TO: Members of the MAG Standard Specifications and Details Committee

SUBJECT: MEETING NOTIFICATION AND TRANSMITTAL OF TENTATIVE AGENDA

MAG Standard Specifications and Details Committee
TENTATIVE AGENDA
May 2, 2012

ASPHALT PAVEMENT
SAFETY EDGE

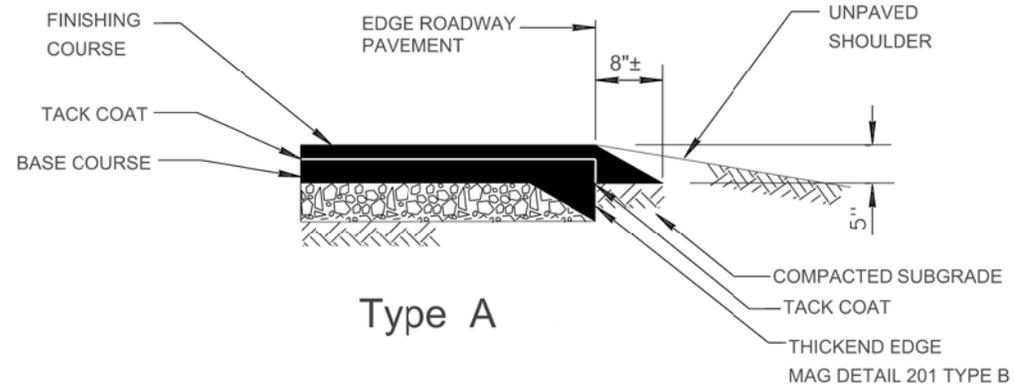
Add an Asphalt Pavement Safety Edge option to Detail 201. Bob Herz handed out a revised detail drawing dated 4/4/2012. The revised detail dropped the specialized overlay option. He said that although there was discussion at the last meeting of removing the text about pay limit for subgrade preparation, MCDOT engineers would prefer to keep it in to ensure it is a separate pay item. The detail also added compaction requirements for the replacement shoulder. The overlay uses a saw-cut operation to even the edge. Mr. Herz said that if the width of the cut is greater than 1', the existing pavement would need to be repaired before applying the overlay. Jeff Benedict asked what material was used on the shoulder. Mr. Herz said it would be the existing material. There was discussion about whether the existing material would be able to meet the 95% compaction requirement. Mr. Herz said this is the same requirement for new shoulders, adding the existing material usually is pretty good. Mr. Laquey said it is difficult to get consistent compaction measurements on shoulders. It was suggested that the Type A detail be moved above the Type B in the layout, and that the detail number be corrected to 201.

DETAIL NO. 360-1	 STANDARD DETAIL ENGLISH	DRY BARREL FIRE HYDRANT INSTALLATION	REVISED 04-27-2011	DETAIL NO. 360-1
----------------------------	--	---	-----------------------	----------------------------

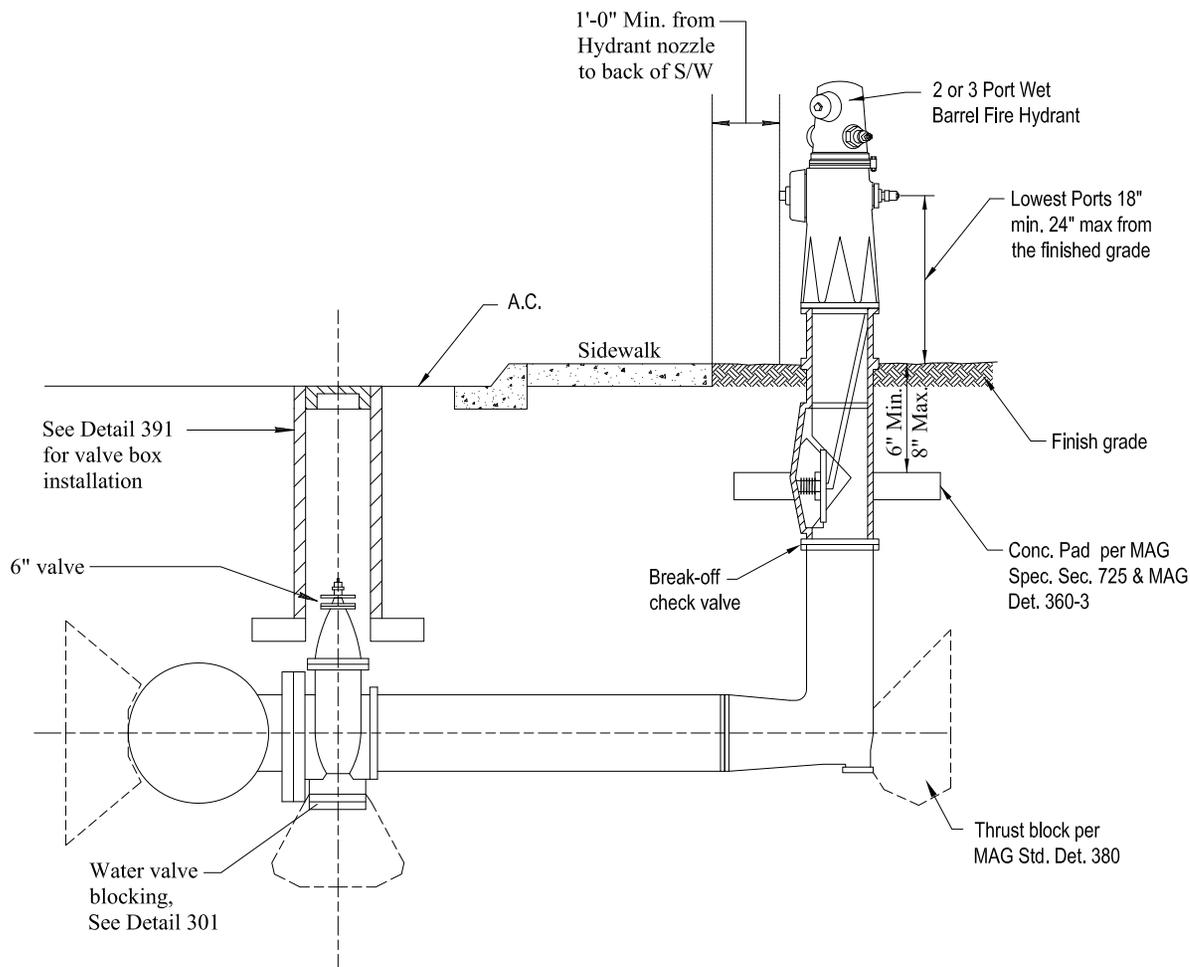
Update Detail 360-1, and add Wet Barrel Option (360-2) and Details (360-3). Craig Sharp, substituting for Scott Zipprich said they are making changes to redlined drawings and plan to bring them to the next water/sewer meeting. After review next month he suggested a possible vote at the following committee meeting.

Buckeye representative Craig Sharp presented the group with the current draft drawings for dry and wet barrel hydrants as well as installation details. Led by Mr. Badowich, the group did a thorough review of the details 360-1, 360-2 and 360-3. Points of discussion included updating the offset fitting detail, concrete pad detail, and removing blocking from plan view details. Several other changes were proposed, and notes were clarified or deleted. Mr. Nebeker suggested using the NFPC standards when applicable. Craig Sharp said he would take these redlines back to his drafter and update the details for the next MAG committee meeting.

SUBJECT: Proposed MAG Detail 249: Modified Entrance

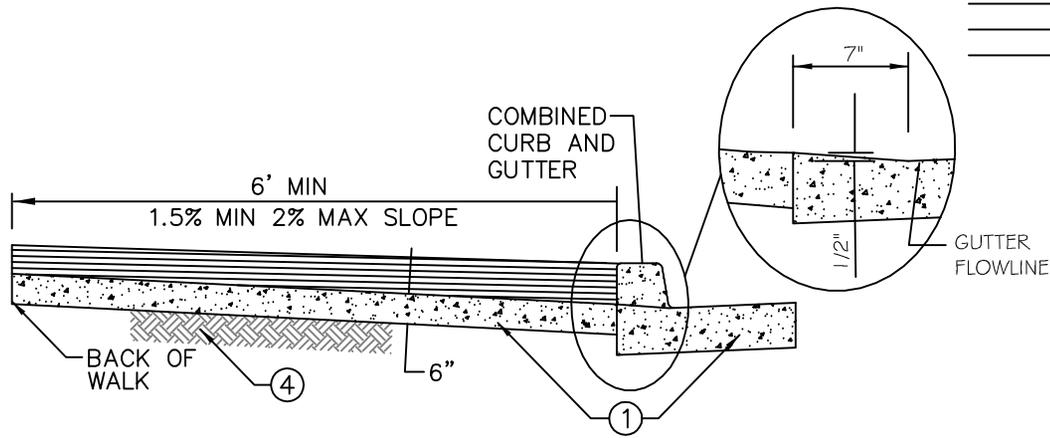
Create a new entrance detail meeting ADA requirements for straight sidewalks. Warren White introduced a case to provide an ADA compliant detail for alley entrances based on one of Chandler's supplements. Bob Herz asked if there was a target slope since the grade of the street can have a big effect of the size of the ramps in order to keep the 1/12 max slope. He suggested adding the table from the other ramp details. Rod Ramos further discussed problems on hills and said special designs would be needed, and some limitation placed on when this detail could be used. Tom Wilhite suggested showing where the entrance matches the existing alley grade on the detail. Bob Herz said the walkway could be underwater when there is rain runoff. Rod Ramos suggested deleting the detectable warning strips, saying they are not typically used for driveways or alley entrances unless there is a lot of free-flowing traffic. He noted that they can also be broken by garbage trucks. Tom Wilhite recommended changing the width from 6' to 5' to be consistent with other sidewalk details. Bob Herz recommended changing the title to Alley Entrance and using the same number as the old detail it is replacing. (Note: was Detail 260.)

Proposed new ADA Compliant MAG Detail 249 for alley entrances, etc.
